MEMORANDUM FOR: T. A. Ippolito, Chief, Operating Reactors Branch #3, DOR
FROM: J. N. Hannon, Project Manager, Operating Reactors Branch #3, DOR
SUBJECT: MEETING SUMMARY

A meeting was held with representatives from BECo (the licensee) and GE in Bethesda, Maryland on February 29, 1980. The purpose of the meeting was to discuss the recently discovered Pilgrim Core Spray Sparger cracks, associated analysis, and plans for resuming power operation at the Pilgrim Station after the current refueling outage. A list of meeting attendees, agenda, and slides used during the presentation are enclosed.

BOSTON EDISON CO.
PILGRIM STATION
CORE SPRAY
AGENDA

CORE SPRAY SPARGER
ELEVATION VIEW

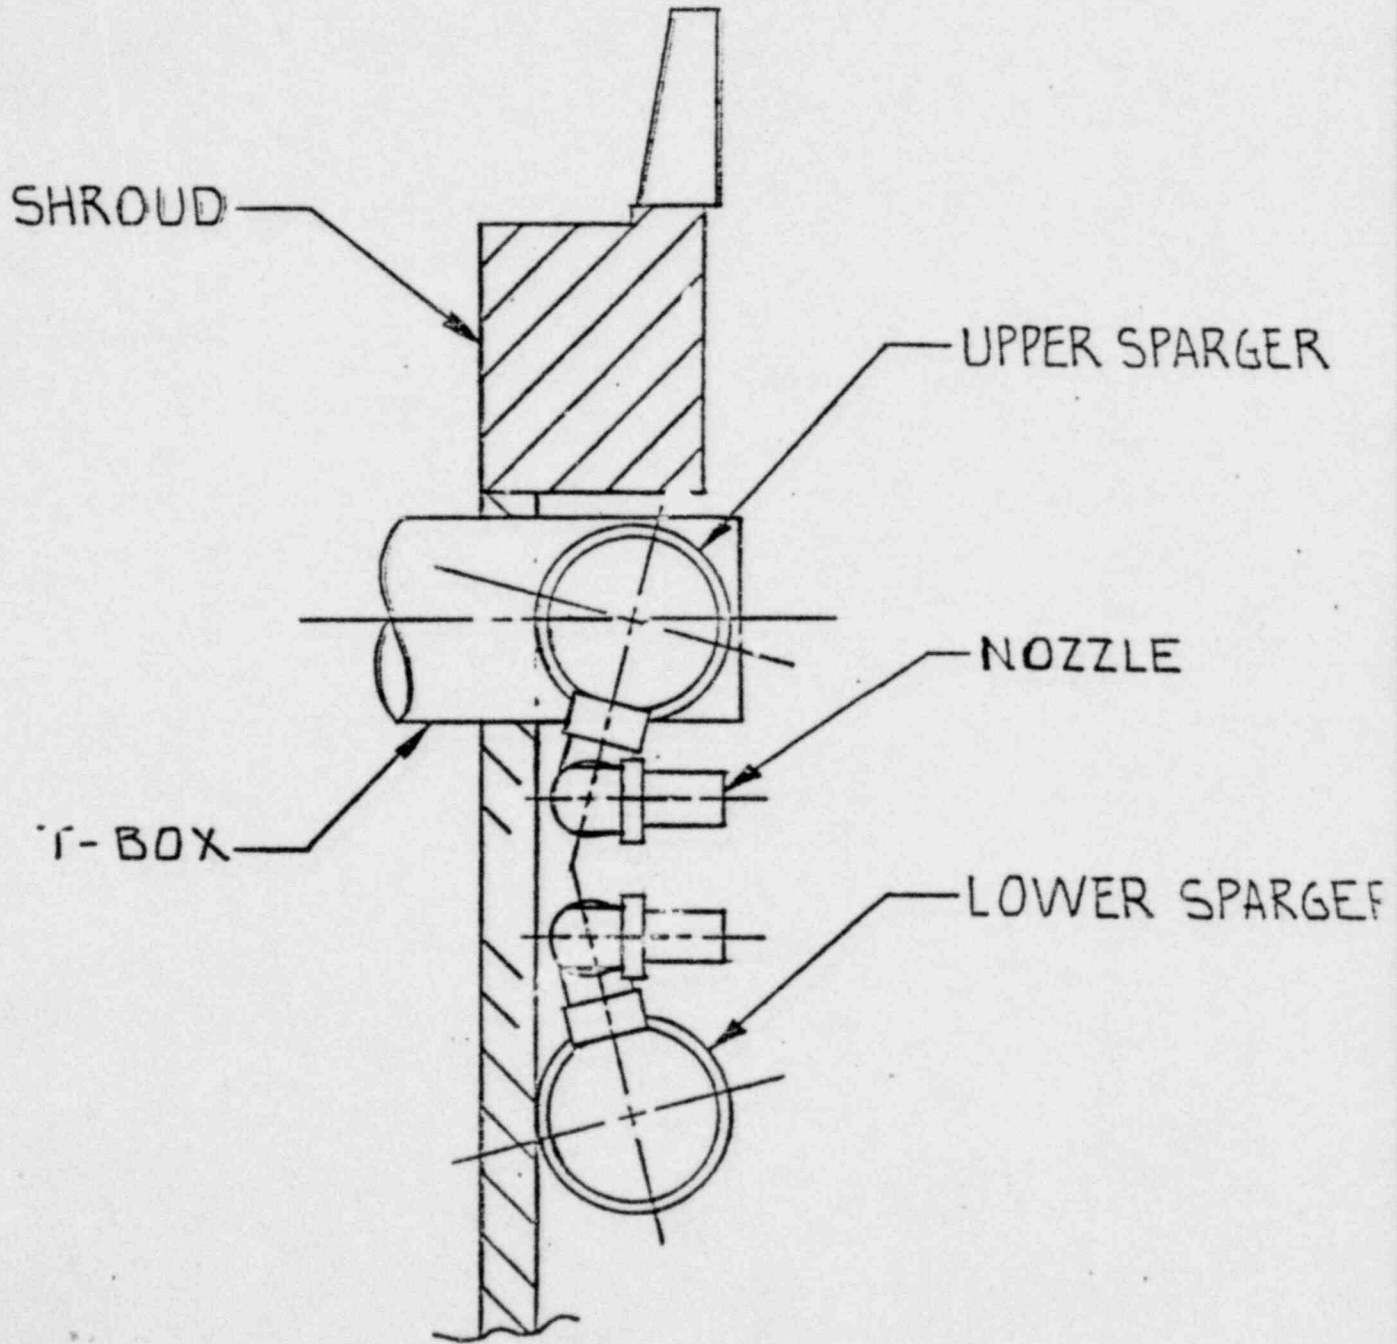
- CRACK INITIATION/GROWTH
 - INNER SPARGER BEND RADIUS IN HIGH LEVEL OF RESIDUAL TENSION
 - THEREFORE, CRACKS MOST LIKELY AT INNER SPARGER BEND SURFACES
 - IGSCC IN TYPE 304 STAINLESS STEEL PIPE WELD HAZ's HAVE TYPICAL LENGTH TO DEPTH RATIOS OF 5:1
 - FOR THIN WALLED PILGRIM SPARGER - CRACKS > 2-INCH (EVEN IF I.D. INITIATED) SHOULD BE VISUALLY DETECTABLE

WELD HAZ OF SPARGER
TO TEE BOX JOINT
MOST LIKELY LOCATION

- STRESSES LITTLE AFFECTED FOR NORMAL PLANT OPERATION
 - EXCEPT - SECONDARY BENDING STRESSES DUE TO INSTALLATION RADIAL MISMATCH WILL INCREASE WITH DECREASE IN SECTION MODULUS-- BUT IS DEFLECTION LIMITED.
- SPARGERS SECURELY ATTACHED TO SHROUD
 - EXCEPT - SPARGER ENDS (APPROX.) 1 1/2" OUTSIDE END BRACKET.
NOT A LOSSE PART CONCERN
- STRESSES LOW FOR CORE SPRAY INJECTION EVENT
 - AXIAL LOAD FROM P & BRACKET FRICTION
 - SECONDARY BENDING FROM CHANGE IN BEND RADIUS
 - TORSION DUE TO NOZZLE FLOW
 - WEIGHT-FULL OF WATER

- SPARGER FLOW DISTRIBUTION MAY BE AFFECTED

- CORE SPRAY WATER WILL BE DELIVERED TO SHROUD INTERIOR
- SPARGER SHOULD RETAIN STRUCTURAL CONTINUITY
